Docket Item #7  
BAR CASE #2003-0218

BAR Meeting  
May 26, 2004

**ISSUE:** Rear addition  
**APPLICANT:** Sheila Farrell  
**LOCATION:** 409 North Henry Street  
**ZONE:** CL/Commercial

**Figure 1 - Rear Elevation**

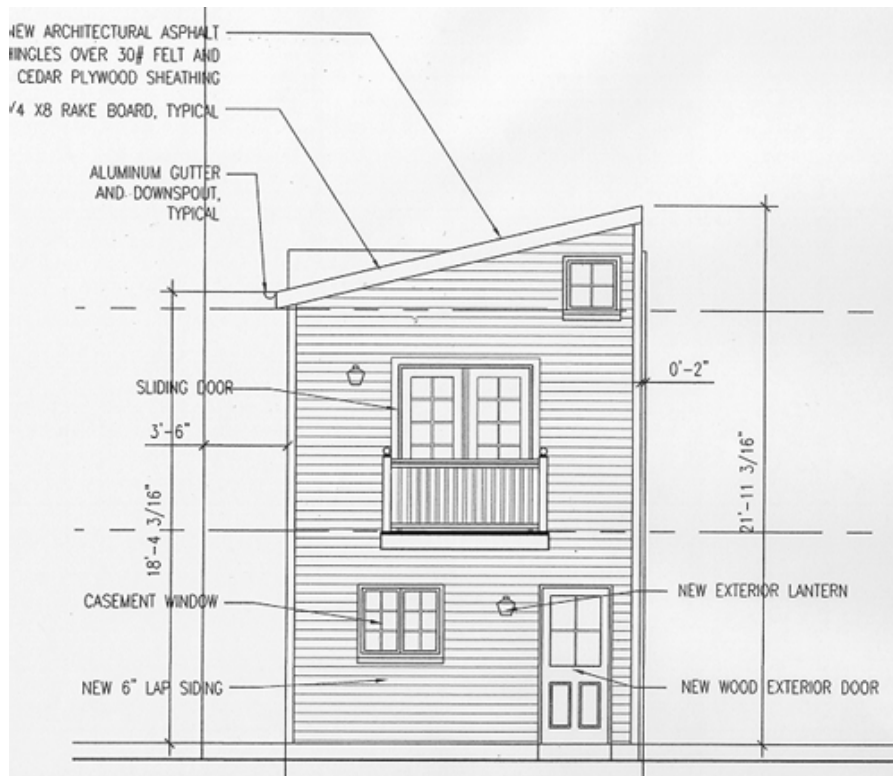
The rear or east elevation will have a door and window on the first story. The window will be a multi-light casement. Its location, dictated by the location of the kitchen sink, is slightly to the south of the centerline of the east elevation. The door, located at the north end of the east elevation will be wood and will have four lights above two panels. There will be an exterior light fixture to the side of the door. No details were provided for the light fixture. The second story will have a pair of multi-light sliding doors. A railing with straight pickets and straight posts surmounted by a ball finial will be flush against the sliding doors. Mr. Carr has confirmed to Staff that the railing is wood. A light fixture will be located to the south of the sliding doors. Again, no details were provided for the light fixture. Above the sliding doors, at the extreme north end of the facade, will be a small four light window.

At the previous hearing, the Board expressed concern over the arrangement of the window and door openings on the rear (east) elevation, suggesting this elevation should be simplified and made more symmetrical. Staff reiterated this concern in a subsequent meeting with the applicant and his architect. While the design has been revised, Staff believes the elevation remains awkward and haphazard. One can only assume that the applicant feels the programmatic needs of the interior do not allow for any further modifications in this area. Similarly, the revised design does not reflect the Board's recommendation that the muntins be eliminated from the windows and doors to further simplify the design. Staff again recommends that the muntins be eliminated.

1. That the addition be reduced in height by 2';
2. That the small windows at the upper north end of the east and west elevations be eliminated;
3. That the muntins be eliminated from the windows and doors on the addition;
4. That the sliding doors, windows, railing and trim be wood (no aluminum or vinyl cladding);

**Figure 2 - North elevation**

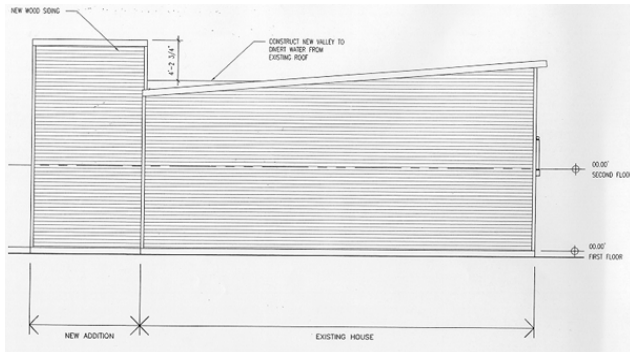
The north elevation of the addition will be blind. The south elevation will have a small four light window on the first story. The west elevation of the new addition will project several feet above the roof of the existing house. There will be a small four light window at the high (north) end of this elevation.

**Figure 5 - Current Submission**

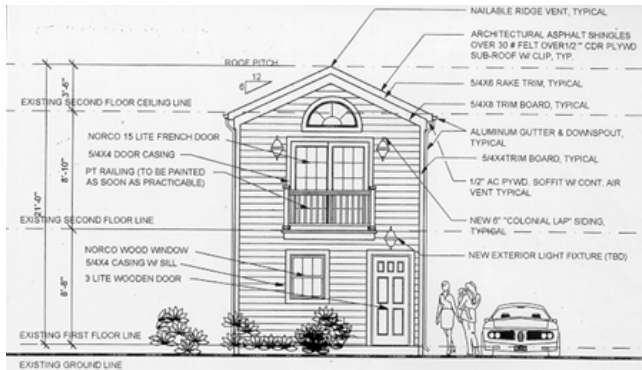
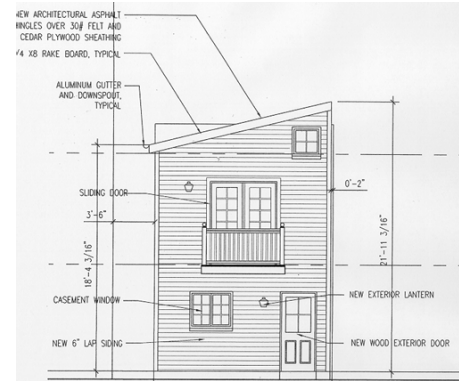
Staff is pleased to note that the applicant addressed several of the Board's comments from the February 25, 2004 hearing in the revised design for the addition to 409 North Henry Street:

1. The addition is now a flounder. The flounder is a more traditional form than the previously proposed gable end addition and addresses the drainage concerns with respect to the property to the north.
2. The fanlight over the second story sliding doors has been omitted.
3. The exterior light fixtures are smaller and the light for the first story door is now located beside, rather than above, the door.
4. Vertical trim boards have been added to demarcate the new addition from the existing house.
5. The interior plans and exterior elevations now correspond.

However, Staff does continue to have concerns about the proposed design. While Staff believes the flounder form is a good solution for this property, the flounder shown in the revised plans seems excessively tall in relation to the historic house. Although the addition may not be visible above the historic house from directly across Henry Street, it will be visible from the north side in the winter when the leaves are off the trees fronting the parking lot to the north of the house. Staff notes that the previous gable end addition was not as tall as the currently proposed addition. The current plans show the ceiling height in the second floor of the addition starting at 9' on the

south side and rising to 12'3" on the north side. Staff believes the overall height of the addition could be reduced by 2' without sacrificing comfort. While the room would be 7' high at the south end, more than 3/4 of the room would be over 8' high and it would be over 10' at the north end.. The excessive height of the second story seems to be dictated by the desire to add the small attic type windows on the east and west sides of the addition. Staff discussed alternative means of lighting this area, such as with skylights or a band of windows on the south side, with the applicant and his architect, but they were not used.
